STAGE 1 ROAD SAFETY AUDIT
RESPONSE

JOB Limerick Student Accommodation			
CLIENT Ladys Lane PBSA			
DRAWING Audit Response			
DRN	MB	CHECKED	CG
DATE	16-07-26	SCALE	1 in 200 @ A2
Job No.	Drawing No.	Rev.	
26-008-BDB-XXX-DR-CE-009		PL0

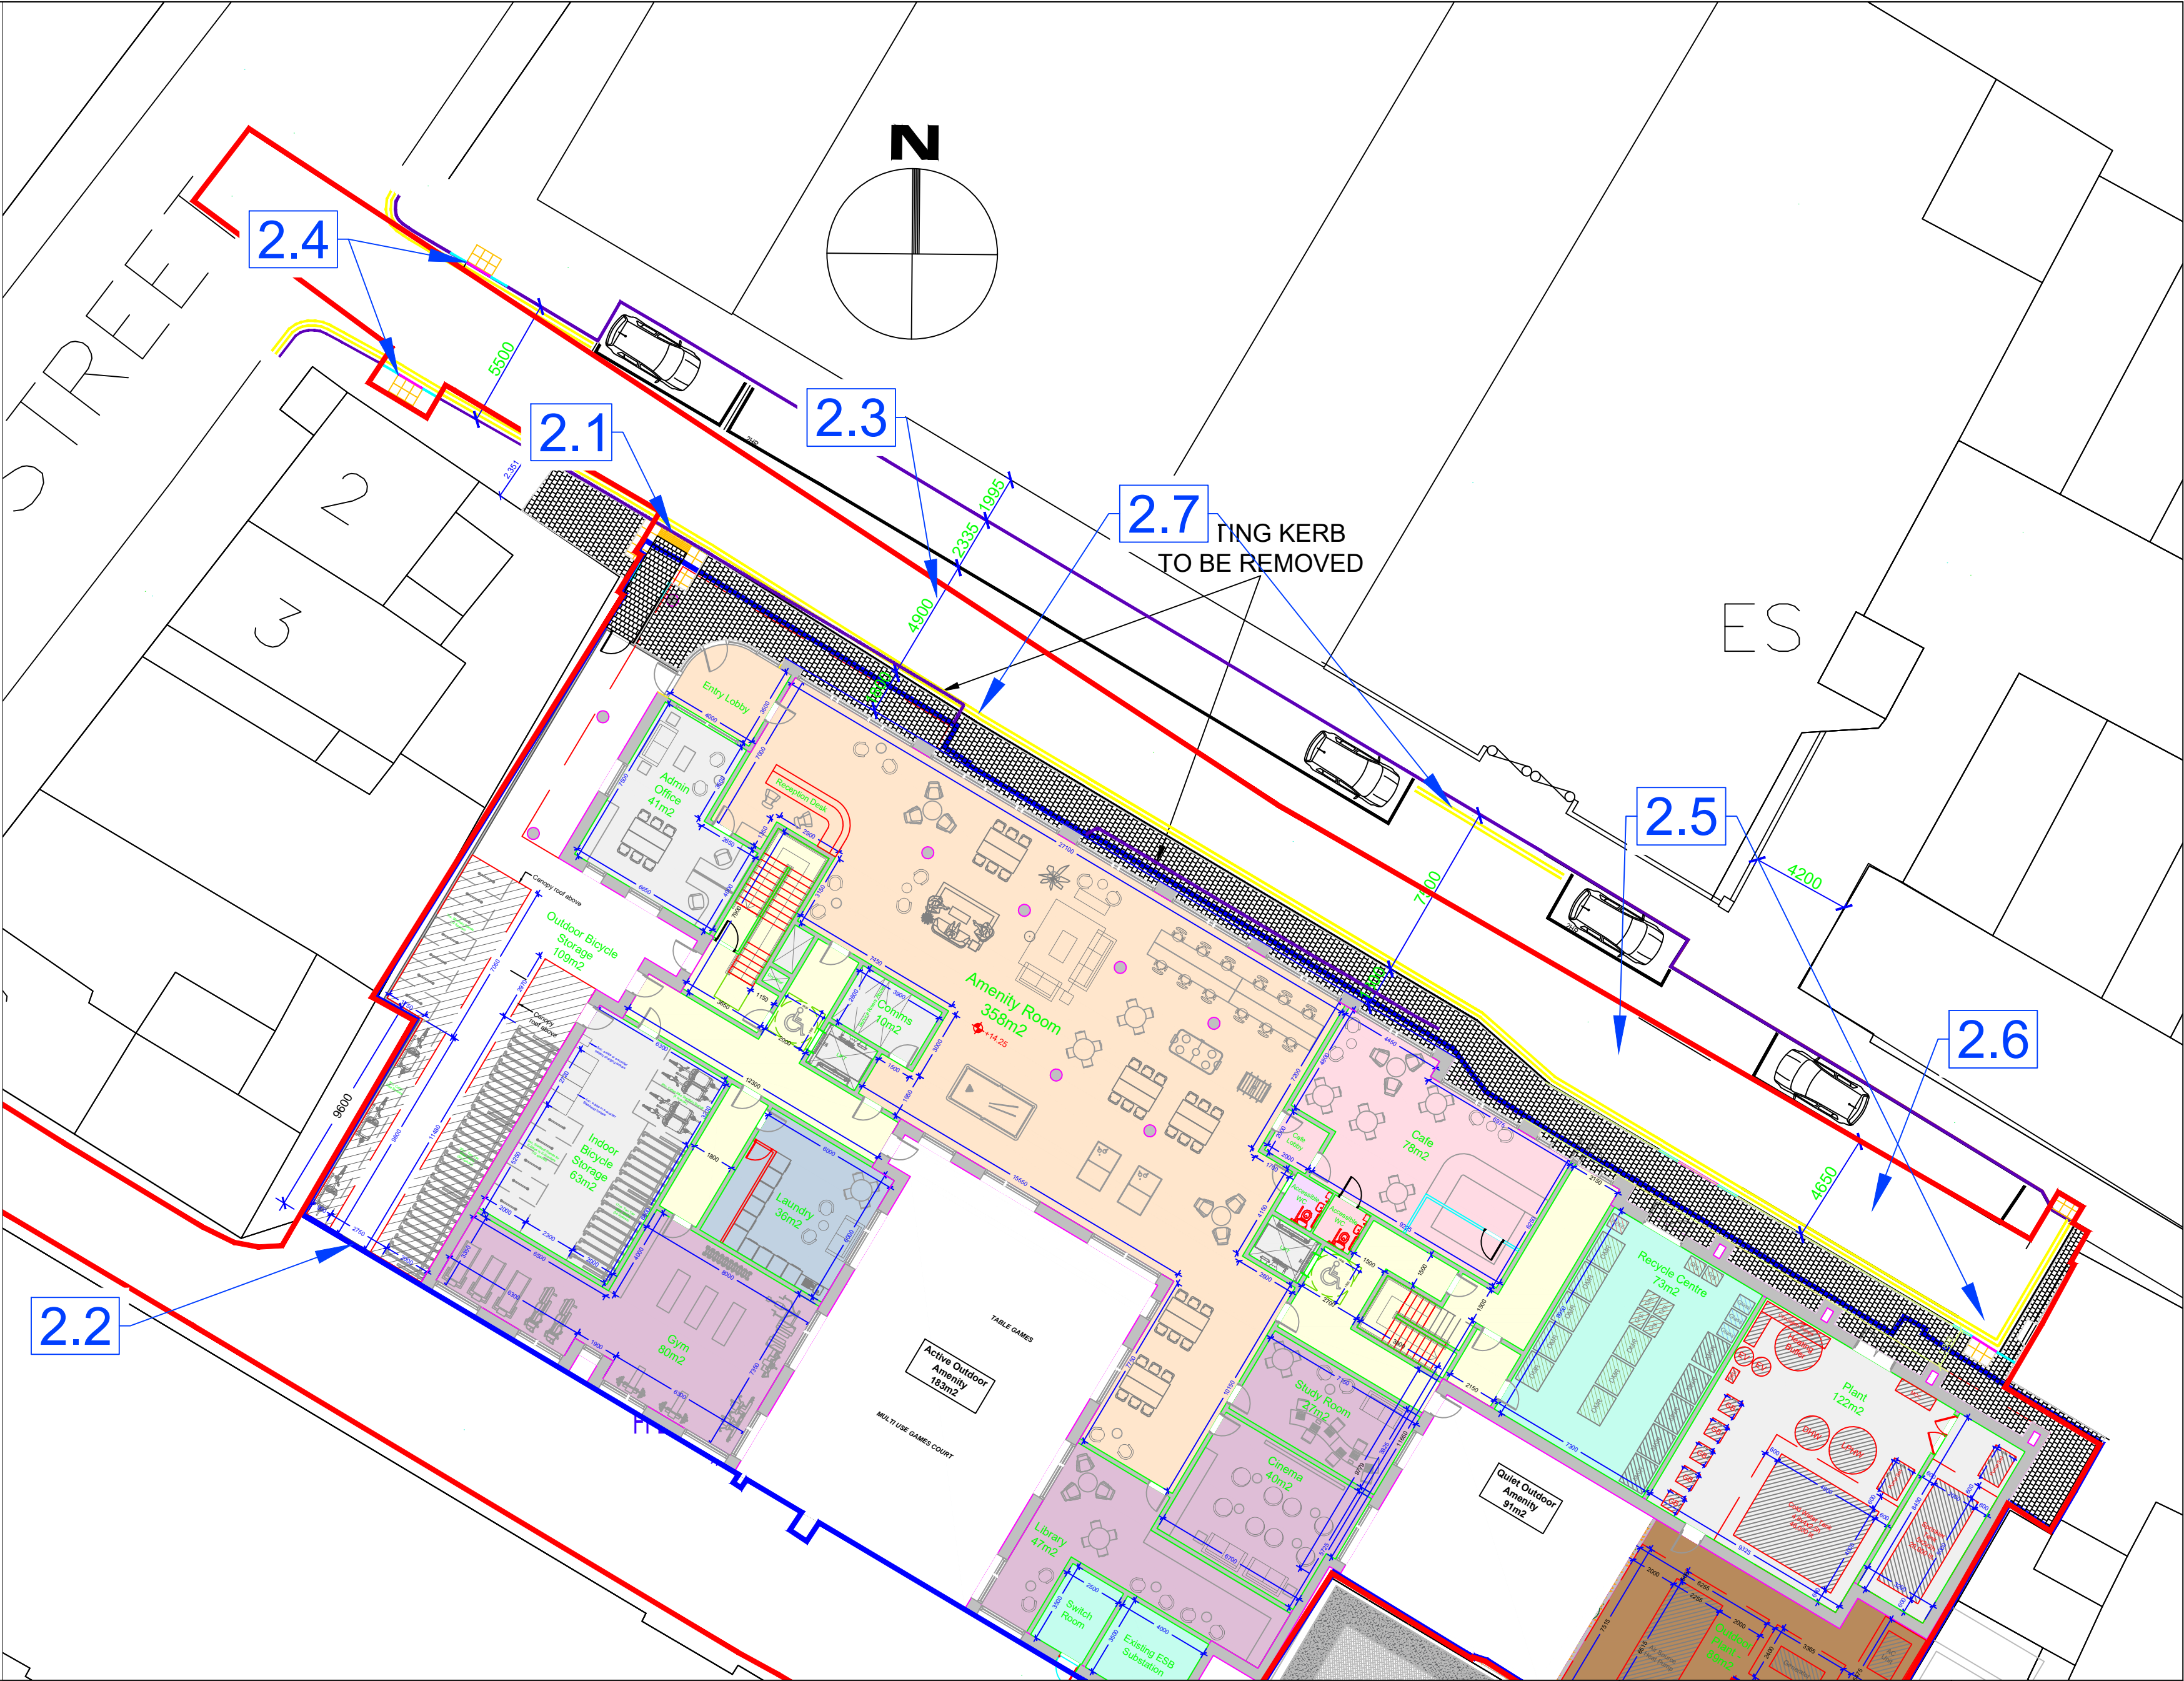
2.1 Problem: Cyclists' Access to the Storage Facility

2.2 Problem: Inadequate Intervisibility

2.3 Problem: Carriageway Width

2.4 Problem: Upstand Kerb at Pedestrian Crossing

2.5 Problem: Pedestrian Crossing

2.6 Problem: Turning Area

2.7 Problem: Parking Restrictions

Response: Cycle storage access identified through the use of a high kerb either side of the entrance and dropped kerb along the road. Tactile paving to identify pedestrian crossing.

Response: No exit or entrance at this location.

Response: Revision to the building front elevation has resulted in the footpath being able to move and increasing the road width. The footpath has a width of 1.8m with road width off 4.9m. An Autotrack exercise was completed and illustrated on drawing 008.

Response: A corresponding tactile and drop kerb is not proposed on the opposite side of the road.

Response: This proposed crossing is now moved east to the end of the lane. This crossing has a dropped kerb and tactile on each side of the road.

Response: With the revised kerb alignment and road widening, Autotrack confirms that cars can turn at the head of the lane. Delivery and refuse vehicles will keep to the existing route and reverse down the lane.

Response: Double yellow lines along Lady's Lane as per drawing 008.
